FINAL PLAT OF "DONALDSON - TALBERT ADDITION"

RE: S/D 99-85 – One-Step Final Plat of DONALDSON-TALBERT ADDITION

RE: S/D 99-85 -- One-Step Final Plat of DONALDSON-TALBERT ADDITION

STAFF REPORT
(One-Step Final Plat Approved 12/2/99)

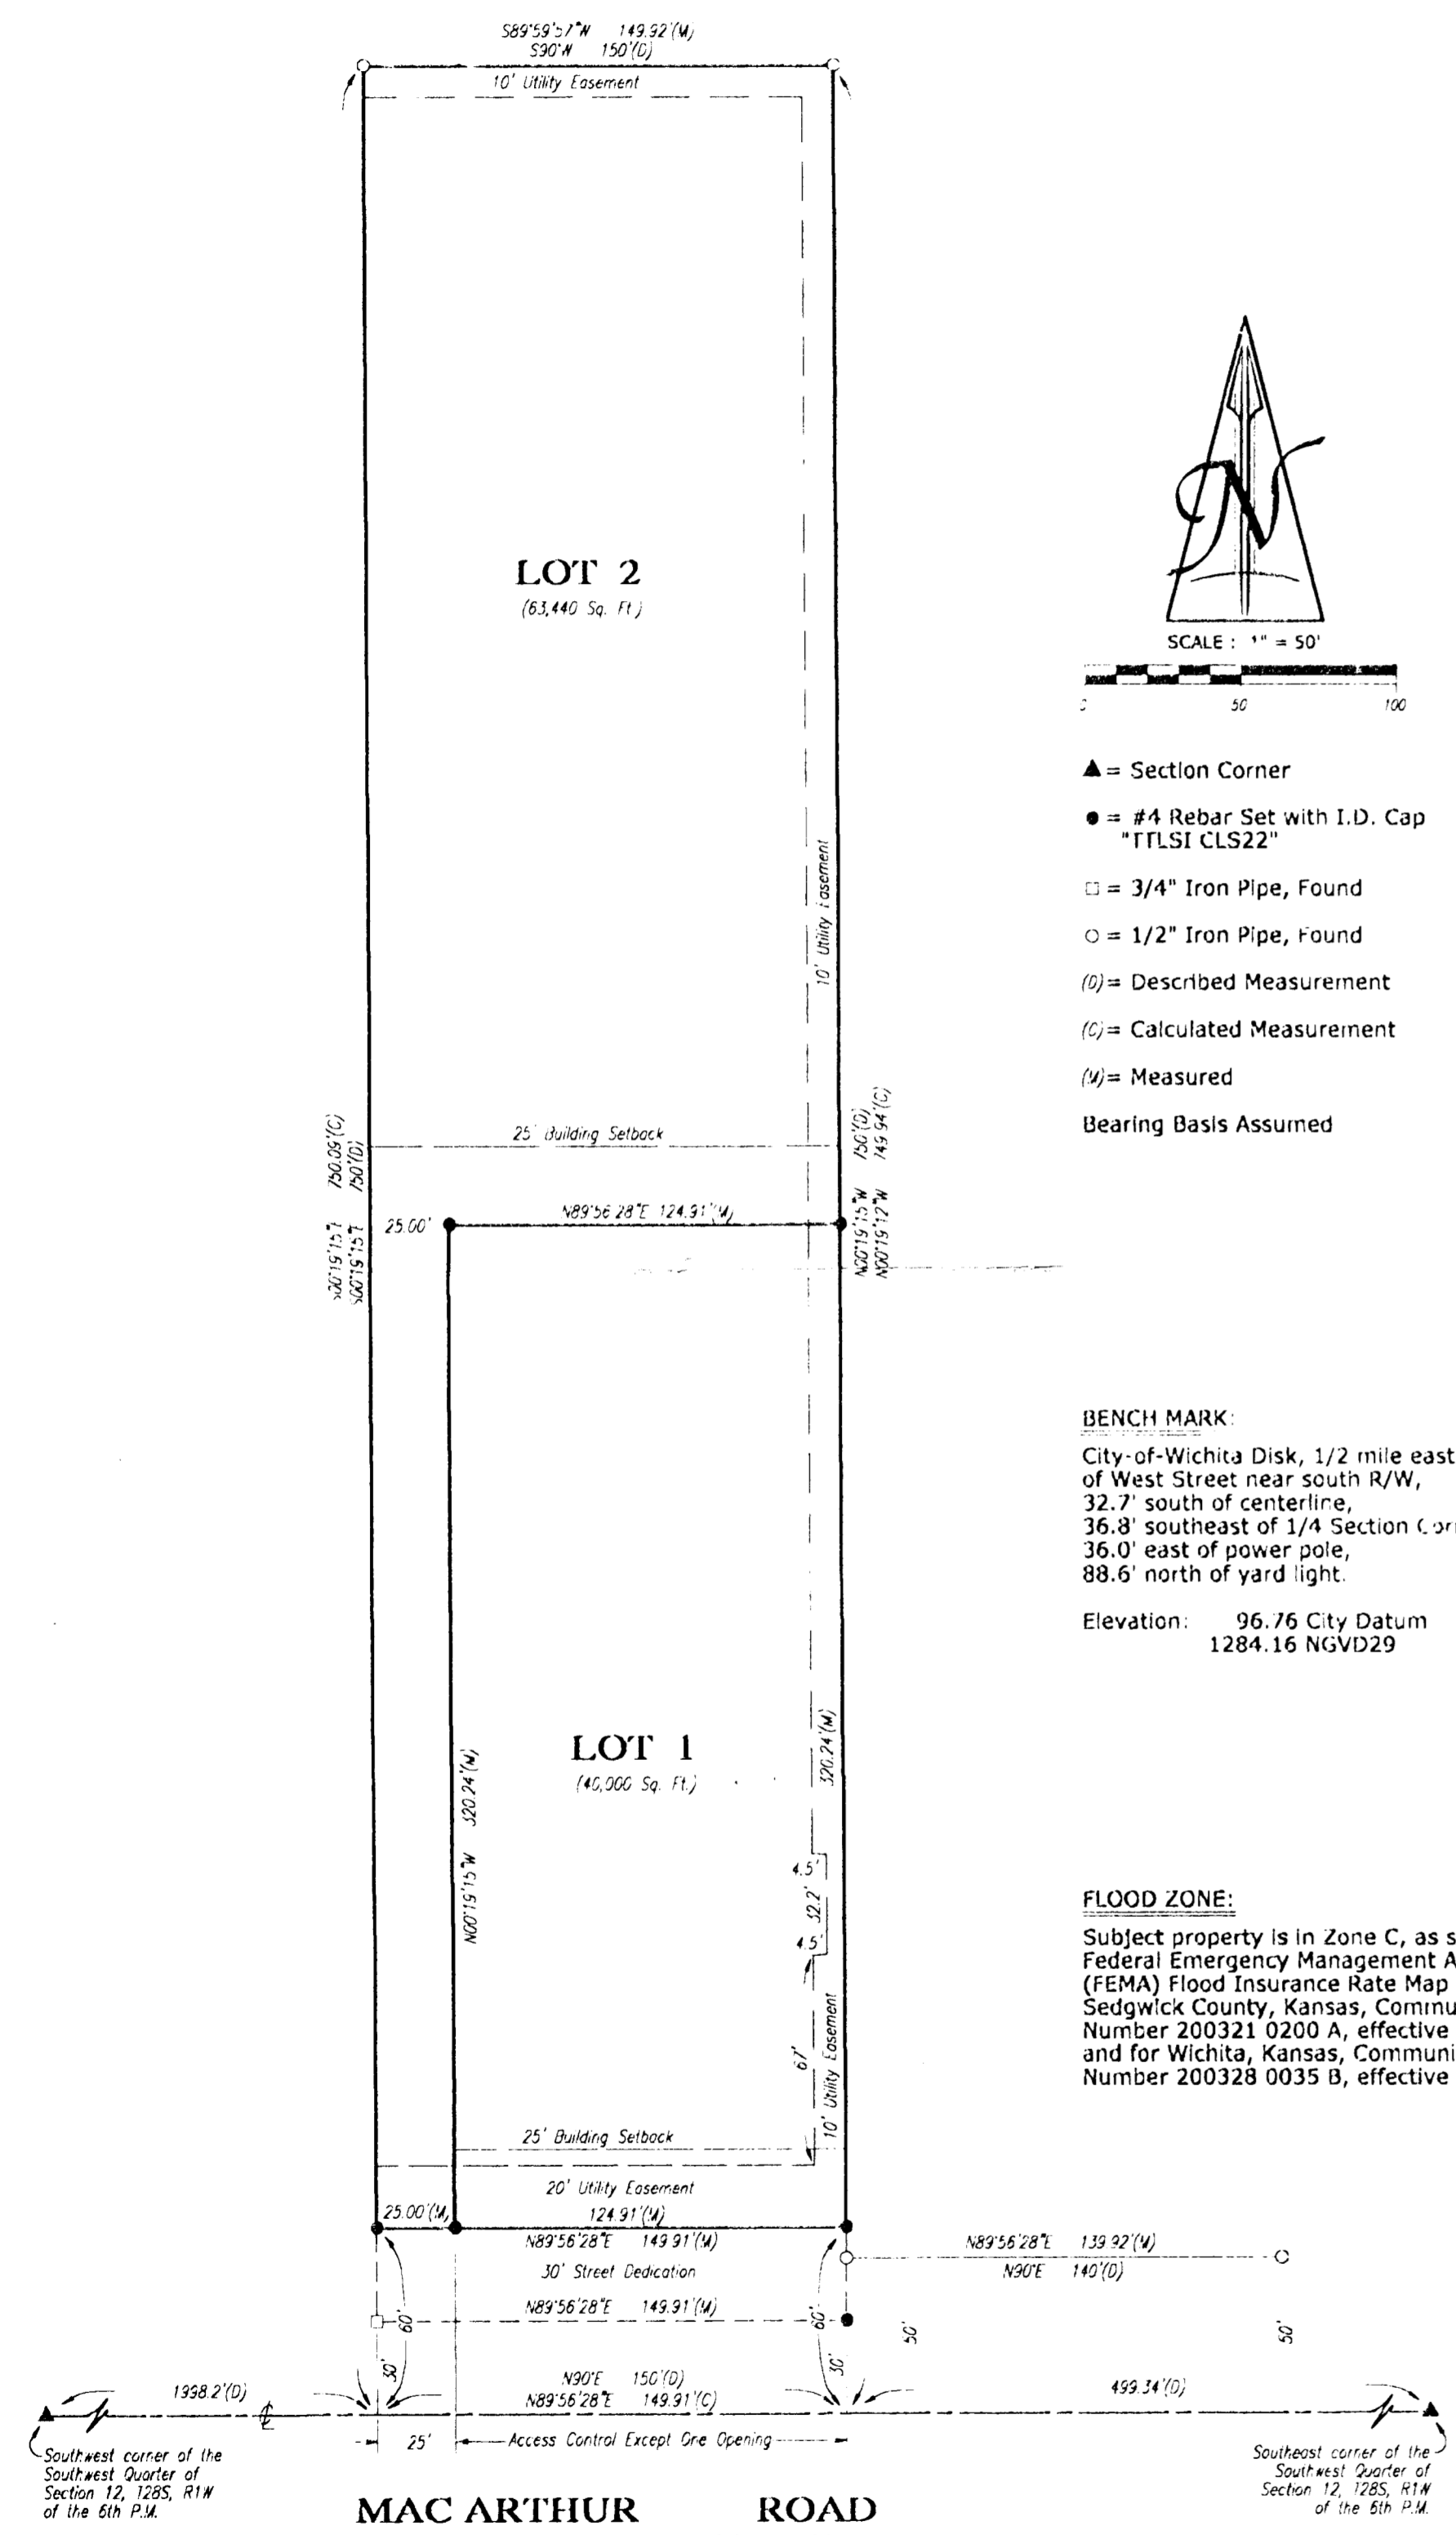
- A. Since this property is adjacent to the City of Wichita, the Applicant shall request annexation into the City. Upon annexation, the property will be zoned SF-6, Single Family Residential. If annexation is completed prior to the plat's submittal for City Council review, the County Commissioner's signature block may be eliminated.

- B. Since neither municipal water nor sanitary sewer is available to serve this property, the applicant shall contact the Environmental Health Division of the Health Department to find out what tests may be necessary and what standards are to be met for approval of on-site sewerage facilities and water wells. A memorandum shall be obtained specifying approval.

- C. City Engineering requests the Applicant attempt to obtain a valid sewer petition. A petition for future City water (and sewer if applicable), shall be required.

- D. City/County Engineering needs to comment on the status of the applicant's drainage plan. An off-site drainage easement is required.
- E. City Fire Department requires a 20-foot gravel road with a turnaround to within 150 feet of the most remote point of any structure. A site plan shall be submitted to City Fire Department prior to the issuance of a building permit.

- H. This property is within a zone identified by the City Engineers' office as likely to have groundwater at some or all times within 10 feet of the ground surface elevation. Building with specially engineered foundations or with the lowest floor opening above groundwater is recommended, and owners seeking building permits on this property will be similarly advised. More detailed information on recorded groundwater elevations in the vicinity of this property is available in the City Engineers' office.

- I. The platting text shall include language that a drainage plan has been developed for the plat and that all drainage easements, rights-of-way, or reserves shall remain at established grades or as modified with the approval of the applicable City or County Engineer, and unobstructed to allow for the conveyance of stormwater.

- K. The applicant's engineer is advised that the Register of Deeds is requiring the name(s) of the notary public, who acknowledges the signatures on this plat, to be printed beneath the notary's signature.

- O. Perimeter closure computations shall be submitted with the final plat tracing.
- P. Recording of the plat within thirty (30) days after approval by the City Council and/or County Commission.

- Q. The representatives from the utility companies should be prepared to comment on the need for any additional utility easements to be platted on this property.
